UPDATE CHANGE NOTIFICATION

SUBJECT: ON Semiconductor Update Notification # UN16285

TITLE: Die Sales Shipping Material, KNS Metal Ring ref to PCN # 029.

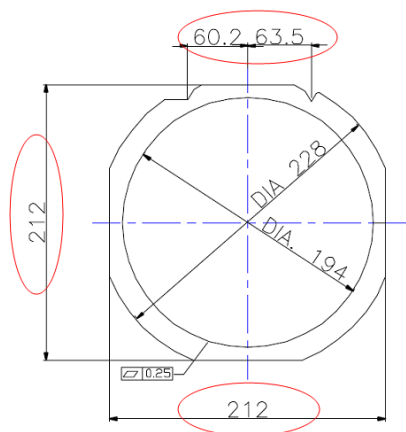
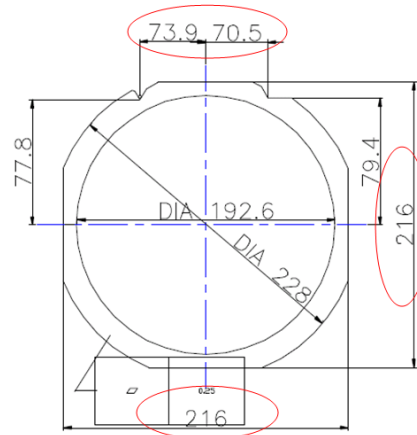
This update change notification provides detailed drawing comparison between the old shipping metal ring and the new shipping metal ring. (See attached drawing)

CHANGE DETAILS:**Today Shipment****SAW WAFER RING****Disco Metal Ring****Future Shipment****SAW WAFER RING****KNS Metal Ring****Advantages:**

Standardize to eliminate opportunity for quality error (Operator using wrong wafer ring).
